RE: Summary of Facts Regarding Violation N92-26-2-1, Cyprus Plateau Mining Company, Star Point Mine, ACT/007/006, Folder #2, Carbon County, Utah

Here is a briefing report on NOV N92-26-2-1:

Sketch

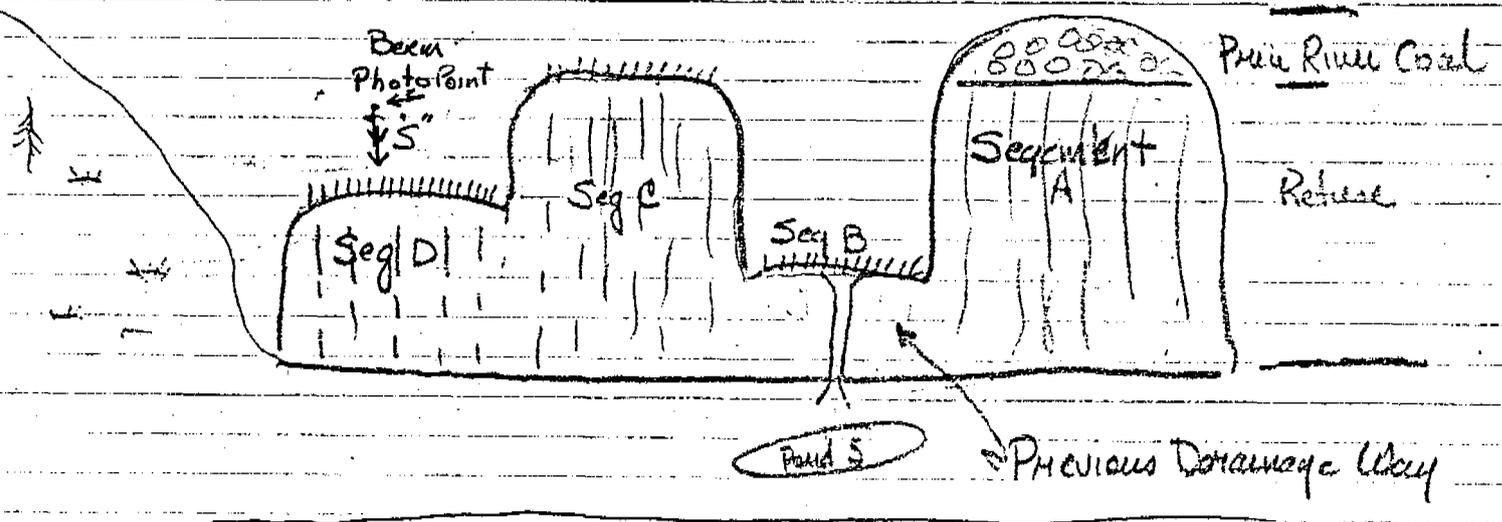
- A.** Southwesterly portion of the refuse pile (see attached sketch).

- B. The major drainage on the refuse pile is in a southerly direction with minor drainage to north and east and hardly any to the west at this time.
- C. The refuse pile relief is more pronounced on the south than on the north. The four refuse drainage segments are readily identifiable on the south and difficult to discern on the north.

The cause of the problem was that the operator constructed a four foot berm and failed to construct a diversion ditch, culvert or other method to discharge the surface runoff. There is a potential to impound water to the height of the berm which may be a safety hazard to men and equipment and may result in refuse slope failure and instability. No runoff was impounded at the time of inspection nor any sign of previous impounding. However, the potential to impound water cannot be refuted.

The operator constructed a berm and culvert (down spout) on the active portion of the refuse pile, segment B, in the summer of 1991. The culvert did not provide drainage from segment D of the refuse pile. The operator asked and was denied a variance to remove the berm.

Refuse pile was in two segments with a drainage way between the two segments (A & C - Sketch).

A. The Price River Coal Pile was moved on top of the easterly segment of the refuse pile (segment A).

1. Eliminate drainage way and utilize it for refuse storage (segment B).
2. Expand the pile to the west - move ditches, etc (segment D).
3. The easterly segment covered by Price River Coal could no longer be utilized for refuse storage.

- B. On the other hand, the operator constructed a berm and culvert to discharge surface runoff from segment B. It is axiomatic from the drainage pattern and topographic relief that after the berm was constructed on the S.W., segment D runoff would impound next to the berm since a "stabilized channel was not constructed at the time the berm was constructed." Therefore, it is my opinion that the operator did not do complete headwork before he started the handwork. In essence, he solved one problem but created another problem.

Design, secure approval, and construct a stabilized channel. Solutions on the refuse pile have taken a piece at a time. At this time, suggest all the issues be brought on the table for a comprehensive solution. I, too, took one piece, i.e., the S.W. segment, but recognize the voice of others should be brought forward and the total problems discussed after the instant piece is adjudicated in the facts of violation hearing.
